# PLANNING COMMISSION STAFF REPORT

Petition No's. 410-07-25 and 490-07-44 North Port Commerce Center Planned Development and Subdivision Located Approximately at 1802 – 1880 North 2200 West.

**Public Hearing Date: March 26, 2008**

**Attachment C – Preliminary Site Plan**

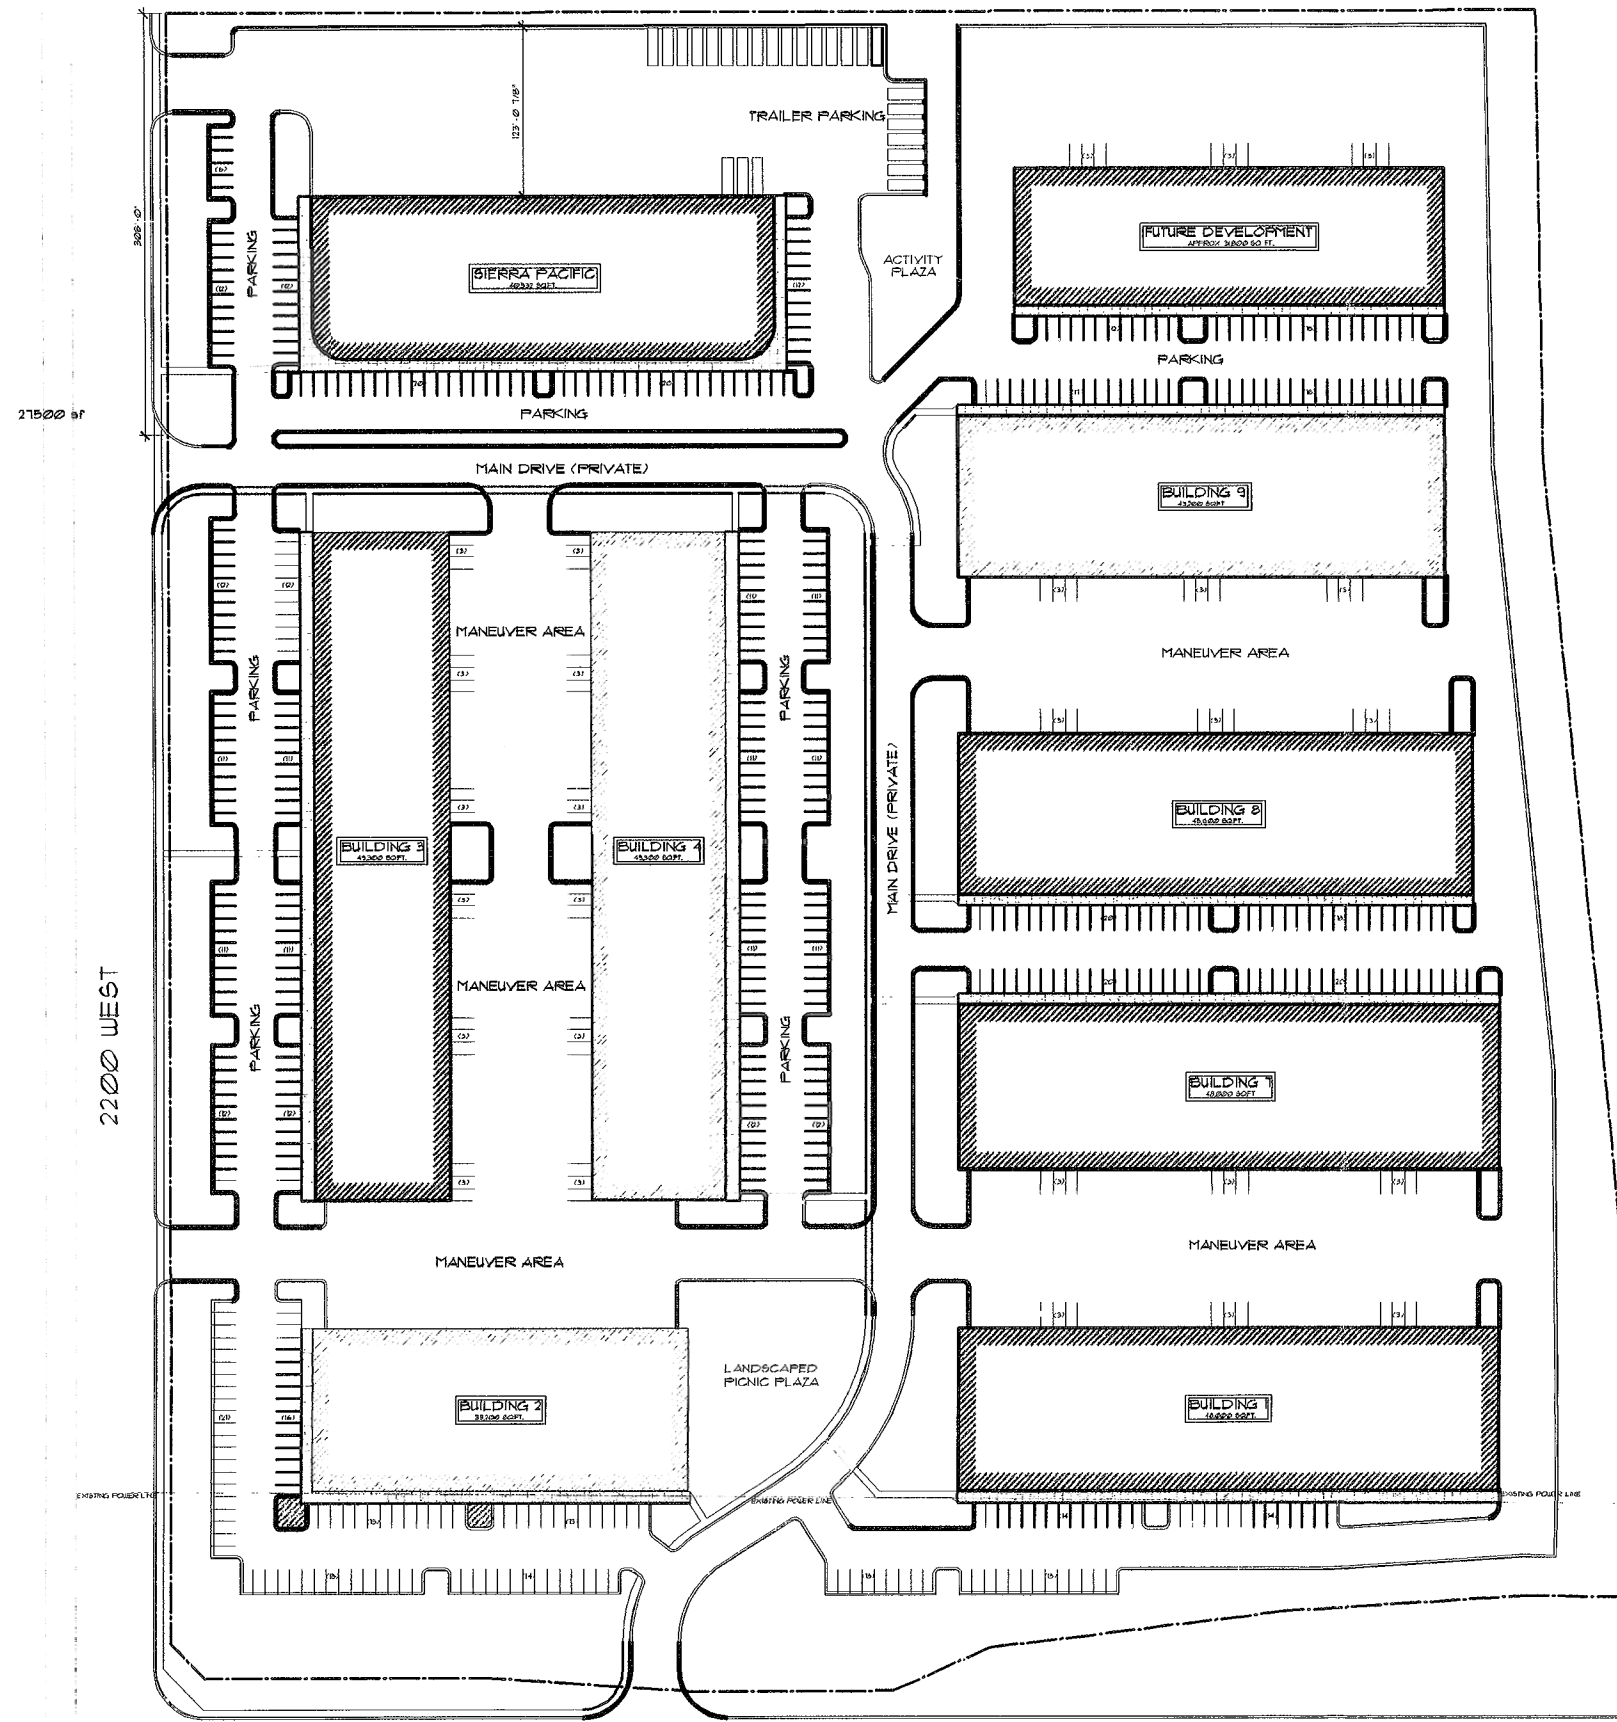
The site plan is subject to DRT review standards. Please show city standard driveways with continuous pedestrian sidewalks along the public way and pedestrian access from the public way to the buildings. Parking layouts need to be fully dimensioned and need to specify ADA stall locations. ADA stalls need details indicating van accessibility and signing. The grading plan needs more details to reflect 2% maximum grades at the ADA stalls and off loading area(s.) Parking calculations are to include 5% bicycle parking for each lot or building development.

- 1) The AS1 sheet submitted for this proposal should include all of the following;
  - a) The property lines of each parcel as determined by the North Port Commerce Center Preliminary Subdivision Plat file #490-07-44 along with the dimensions and legal description of each parcel,

- g) Adequate area along the Interstate 215 frontage of Lot 3 to provide the required twenty (20) feet of freeway scenic landscaping along with any planned site detention (if the freeway scenic landscape area is to be used for site detention, adequate area should be provided such that all required trees and shrubs can be planted above the high water line),

- 1) This development proposal requires that each sheet of the plans specify the Certified Address for the site. The plans currently reflect an address of 1700 North 2200 West. This may cause confusion for the contractor and sub contractors as they look at the plans to determine the address to use in obtaining their permits and calling for inspections. Please correct each sheet to reflect the address of 1880 North 2200 West.

- 3) This development requires that a complete and accurate architectural site plan be submitted which is consistent with any conditions of approval for the Planned Development file #410-07-25 and includes all of the following;

- 8) Parking calculations provided are inconsistent with SLC requirements and therefore provide an incorrect parking requirement for this site. Please adjust the plans accordingly and be prepared to offer an

**Attachment D – Preliminary Landscape Plan**

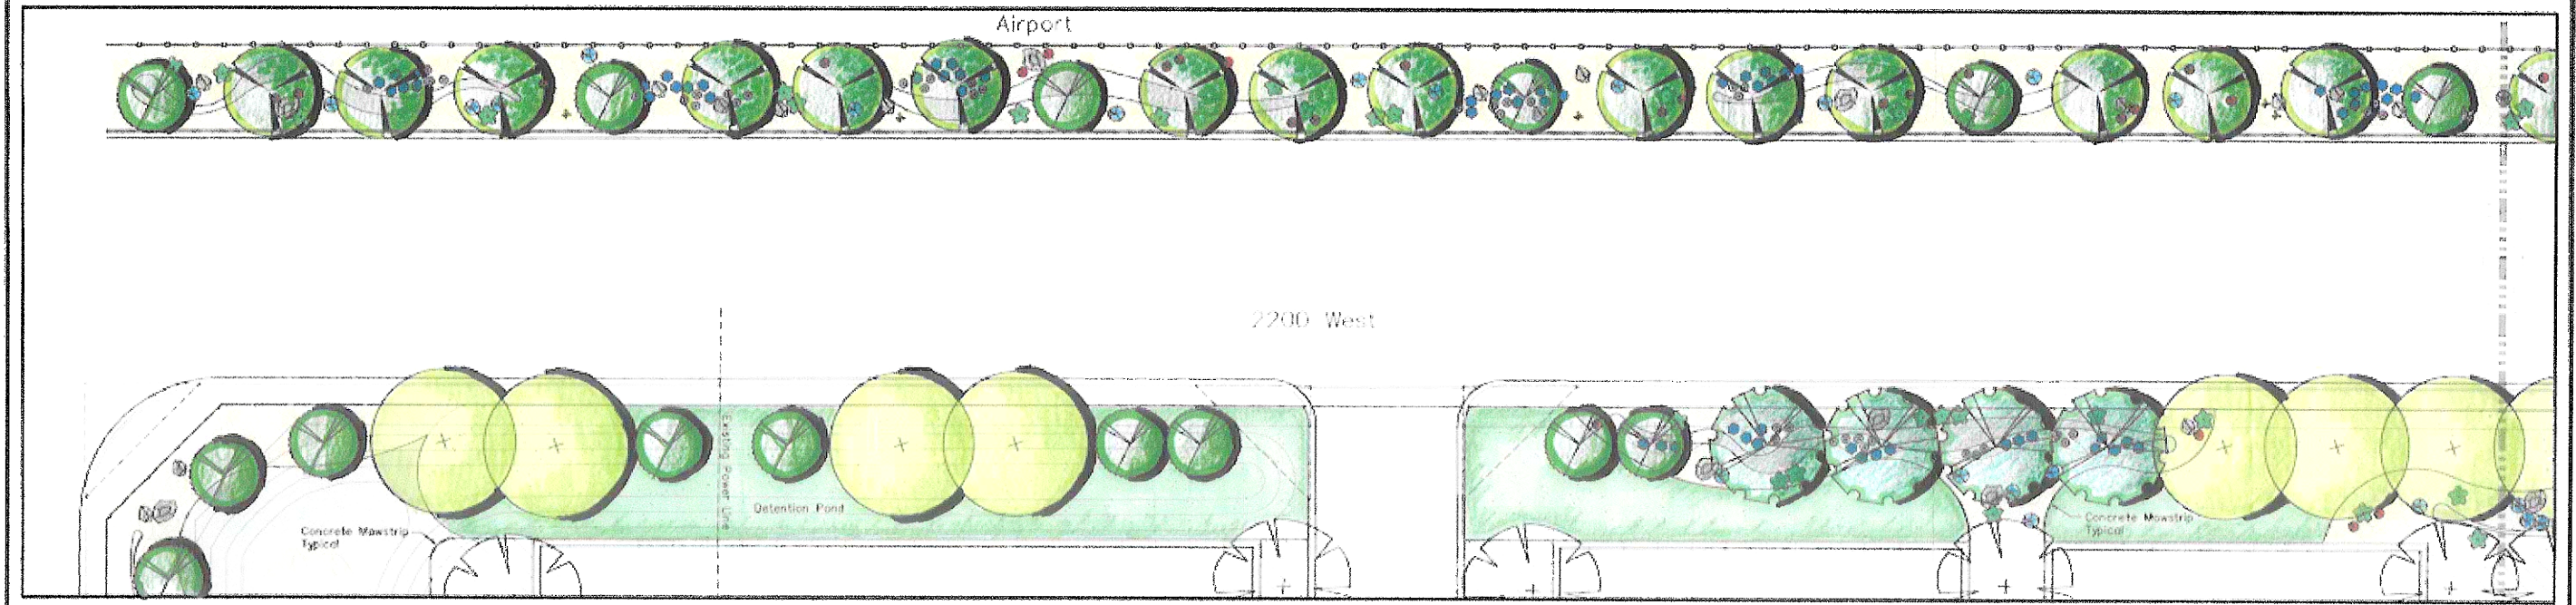
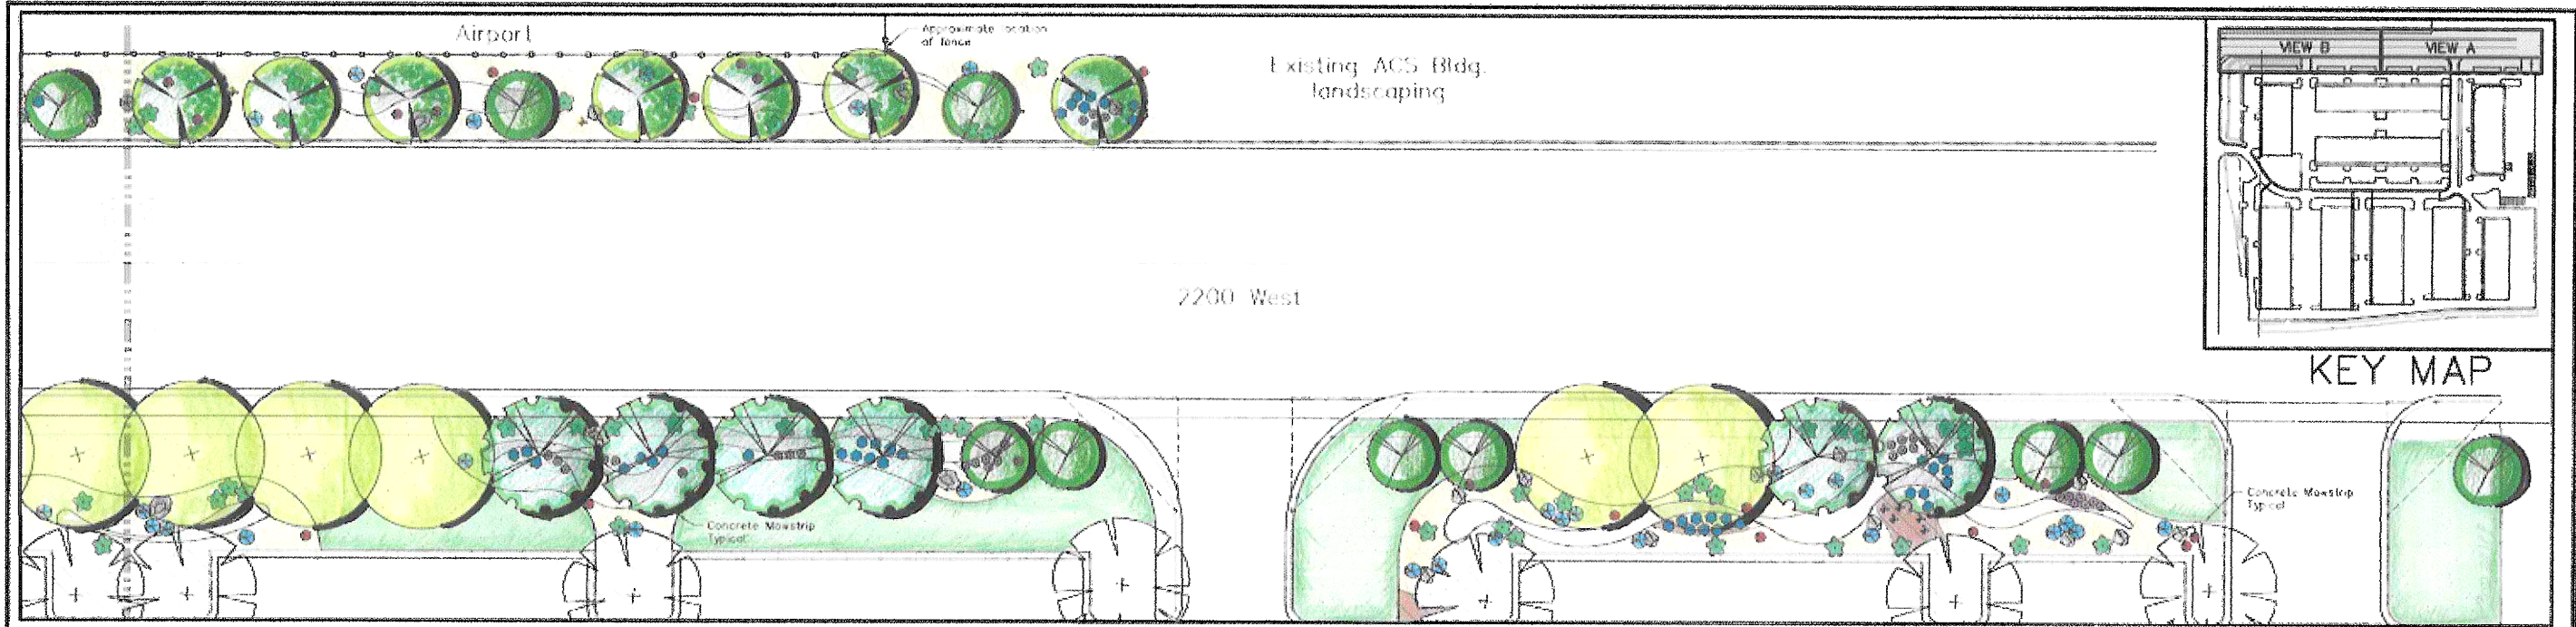
- 2) Recording of Avigation easement to be documented for permit issuance.
- 3) Landscape Plans and Plant Schedules containing the following information will help determine whether this proposal meets the minimum landscaping requirements or in what areas it may be deficient:

- a) The location, quantity, size, and name (both botanical and common) of all proposed plants for each

- lot;
- b) The type and location of all proposed ground covers including both botanical and common names of vegetative ground covers for each lot;
  - c) The location, size, and common names of all existing plants, including trees and other plants in the parkway, and indicating plants to be retained and removed for each lot;

- (viii) Dimension of street frontage and Parkway trees required/provided based on one tree per 30 ft. of lot width (plans currently show very few trees in the parkway strip where they are required to be placed).
